**TOWN COUNCIL APPEALS HEARING
TUESDAY, MAY 10, 2016
Town Hall Council Chambers
551 Hot Springs Blvd
5:00 p.m.**

WAL-MART REAL ESTATE BUSINESS TRUST IS APPEALING THE TOWN PLANNING DIRECTOR'S INTERPRETATION OF LAND USE DEVELOPMENT CODE SECTION 6.11. EXTERIOR LIGHTING, AND HIS FINAL DETERMINATION REGARDING THE NON-COMPLYING NATURE OF THE PARKING LOT LIGHTING AT THE WAL-MART DEVELOPMENT LOCATED AT 211 ASPEN VILLAGE DRIVE.

PROJECT: APPEALS HEARING, WALMART REAL ESTATE BUSINESS TRUST IS APPEALING THE TOWN PLANNING DIRECTOR'S INTERPRETATION OF LAND USE DEVELOPMENT CODE SECTION 6.11. EXTERIOR LIGHTING, AND HIS FINAL DETERMINATION REGARDING THE NON-COMPLYING NATURE OF THE PARKING LOT LIGHTING AT THE WAL-MART DEVELOPMENT LOCATED AT 211 ASPEN VILLAGE DRIVE.

DATE: 08/11/2011
TIME: 10:00 AM
SCALE: AS SHOWN
SHEET: 5

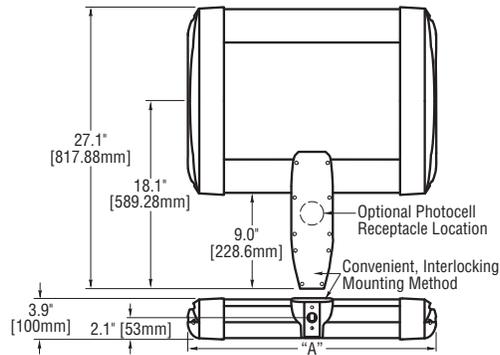
24. **Article 6, Subsection 6.11.4, Paragraph C (Page 170)** states that “in no case shall exterior lighting add any foot-candle illumination at any point off site.” Although minimal, some illumination will occur off site as shown on Sheet 5 of the submittal.

The photometric plan (Sheet 5) depicts areas where a 0.1 foot candle level of lighting occurs off of the site in some locations and in close proximity to the site, within adjacent roadway or open space areas. No light level spills onto properties owned by others in the vicinity of the site. The June 21, 2012 Galloway response letter discusses this issue in more detail, describing the lighting types and technologies used.
